NFPA 70®-2020 Edition
National Electrical Code®
TIA Log No.: 1537

Reference: 210.8(A)(7), Exception (new)

Submitter: Matt Williams, Association of Home Appliance Manufacturers

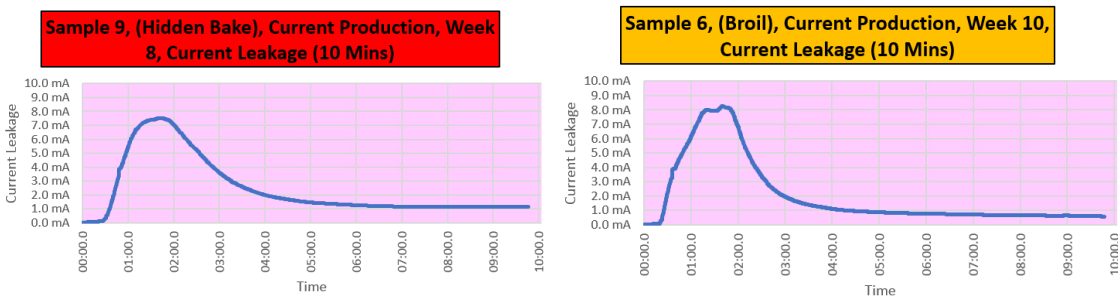
Data shows the range incompatibility issue exists with multiple range manufacturers and multiple breaker manufacturers. The issue is shown in the graphs below. At the initial start-up of the range there is moisture in the elements, the moisture causes leakage current. The moisture is driven off as the element heats up the first time and will not be re-introduced when in the home. The initial spike is above the leakage current limit for a break and will cause the breaker to trip. See the graphs below from the initial runs on a bake and a broil element.

The leakage current is back within acceptable limits within 4 to 5 minutes and will stay there when in operation after this initial startup. The range safety standard does not currently measure leakage current above 125 Volts(see clause 55).

Exception to (7): For receptacles rated 30 through 50 amperes that are supplied by single-phase branch circuits rated 150 volts to ground or less, this requirement shall become effective January 1, 2023.
